ISSUE DATE: 10/24/12 **PERMIT** P 538112
 APPROVAL DATE: 12/4/12 A _____

**ON-SITE SEWAGE DISPOSAL SYSTEM
 HOWARD COUNTY HEALTH DEPARTMENT
 BUREAU OF ENVIRONMENTAL HEALTH**

SUBDIVISION: Buckskin Ridge LOT NUMBER: 27

ADDRESS: 4264 Buckskin Wood Drive PROPERTY OWNER: Columbia Builders

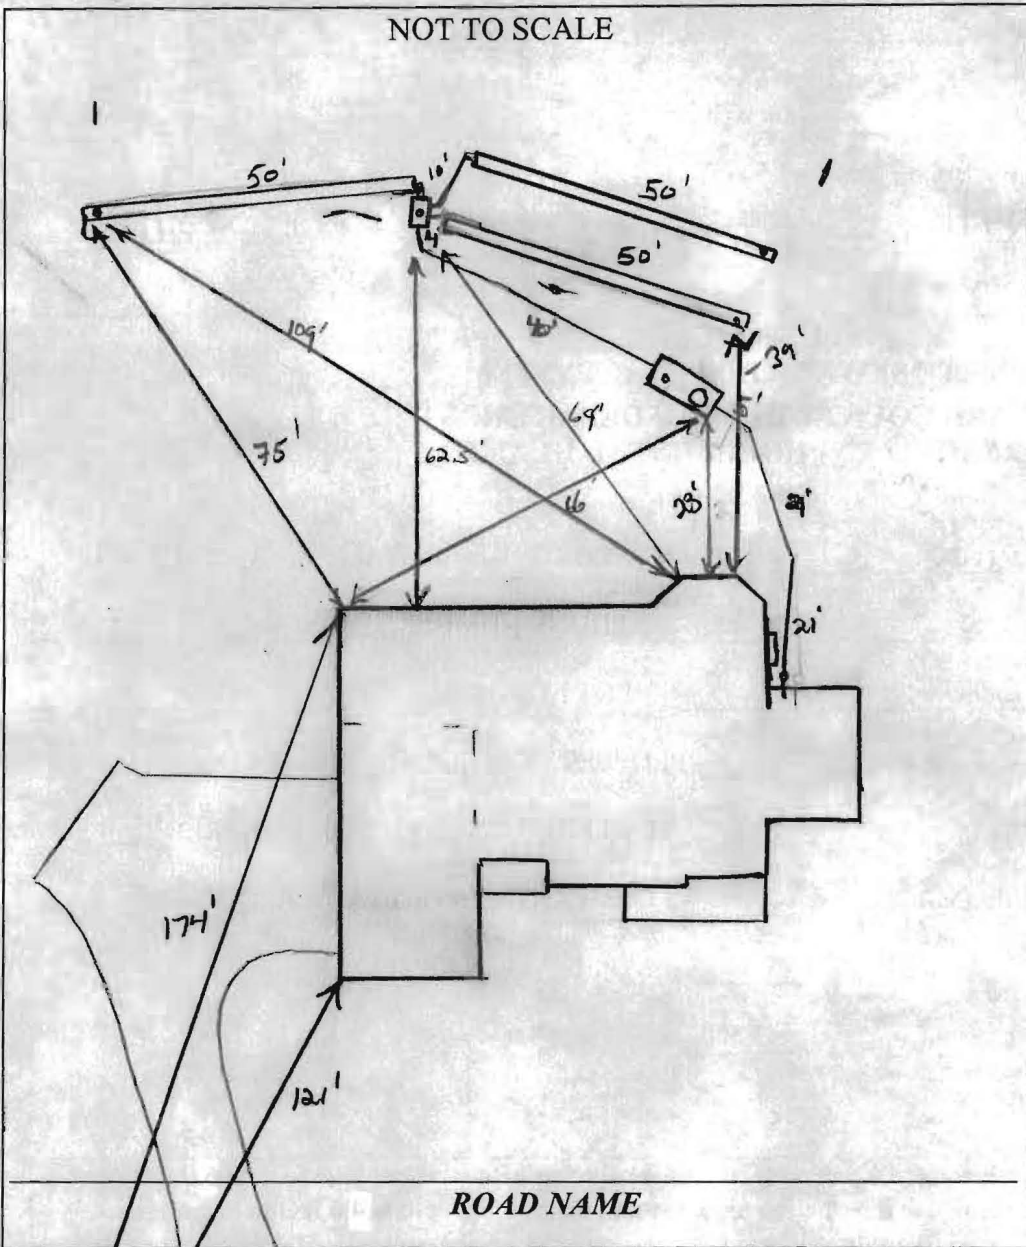
11/30/12 Contour slightly off from permit. Set Dbox top middle part of SEA. Install 3x50' trenches running in both directions. Keep S.T. 20' min from dwelling. Call for inspection (K)

12/3/12 S.T. set. Plumbing run from house to Dbox. Top trench started. Everything looks good. OK to continue (K)
 12/4/12 Trenches complete. Dbox leveled. OK to cover all work (K)
